# Access Compliance Report

## Public Rights-of-Way

### (Curb Ramps)

Intersection ID: 8731	Main Street: BROWNS_AV	Cross Street: SARATOGA_DR	Location:	E
ADA ID: 069BD828FE95	Ramp Type: Perp	Initial Pass/Fail: Fail	Overall Compliance: No	Severity Score: 37.5
Codes/Mitigation Info/Possible Solution		Field Measurements/Component Compliance

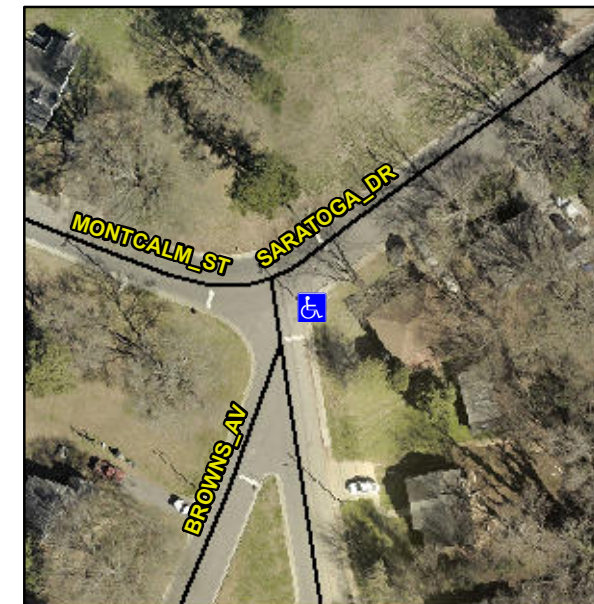
**Remove & Replace Entire Ramp.**

**R304.2.2, R304.5.3**

Compliance	Description	Data	Compliance	Description	Data
N/A	Ramp Length (in)	47.0	No	Ramp Slope (%)	12.3
Yes	Ramp Width (in)	48.0	No	Ramp XSlope (%)	5.5
N/A	Flare Type LT	N/A	N/A	Flare Type RT	N/A
N/A	Flare Slope LT (%)	N/A	N/A	Flare Slope RT (%)	N/A
N/A	Flare Traversable LT?	N/A	N/A	Flare Traversable RT?	N/A
N/A	Landing Length (in)	N/A	N/A	DWS Provided?	N/A
N/A	Landing Width (in)	N/A	N/A	DWS Contrast?	N/A
N/A	Landing Slope (%)	N/A	N/A	DWS Length (in)	N/A
N/A	Landing X Slope (%)	N/A	N/A	DWS Full Width?	N/A
N/A	Landing Curb? (Y/N)	N/A	N/A	DWS Offset (in)	N/A
N/A	Shared Landing?	N/A			
N/A	Gutter Ponding?	N/A	N/A	Gutter Slope (%)	N/A
N/A	Gutter Lip Ht (in)	N/A	N/A	Gutter X Slope (%)	N/A
N/A	Painted X Walk1?	No	N/A	Painted X Walk2?	N/A
	X Walk 1 Direction	To W		X Walk 2 Direction	N/A
N/A	X Walk 1 Width (in)	N/A	N/A	X Walk 2 Width (in)	N/A
	X Walk 1 Slope (%)	3.0		X Walk 2 Slope (%)	N/A
	X Walk 1 X Slope (%)	2.5		X Walk 2 X Slope (%)	N/A
